# SERVICE BULLETIN

**AA-SB-27-003**

## Rudder Bar – Inspection & Replacement

**Figure 1**

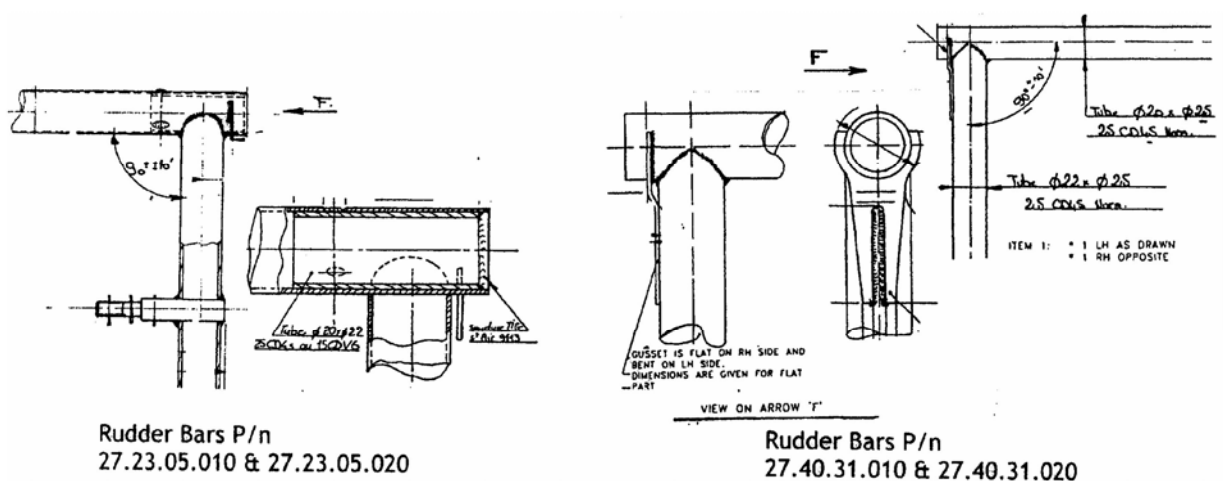
Replace rudder bars P/N 27.23.05.010 and 27.23.05.020 (LH & RH) with rudder bars P/N 27.40.31.010 & 27.40.31.020 (LH & RH) in accordance with the compliance instructions in 1.5. To aid identification of the different part number rudder bars refer to Fig 1.

**Figure 2**

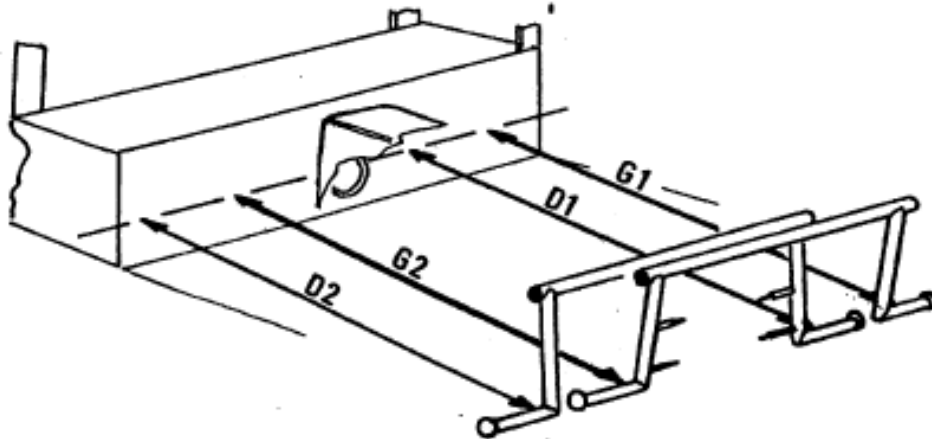
Model R2100, R2100A, R2112, R2160, R2160D and R2160i aircraft: Replacement is required.  
Model R2120U and HR200 Series: Replacement is recommended. Measure the rudder bars for distortion in accordance with Fig 2. If distortion is equal to or greater than 10mm then replace both rudder bars.

Maintain the rudder bars in the neutral position and measure distances G1, G2 and D1, D2. The difference between G1 and G2, or D1 and D2 is the distortion.

1. If  $D1 = D2$  and  $G1 = G2$  ( $\pm 5$  mm), there is no significant distortion and no action is required, re-inspect at intervals not to exceed 500 hrs TIS.
2. If the distortion is between 5 and 10 mm re-inspect at intervals not exceeding 100 hrs, until replaced by P/N 27.40.31.010 and P/N 27.40.31.020.
3. If the distortion is equal to or greater than 10 mm, replace both rudder bars
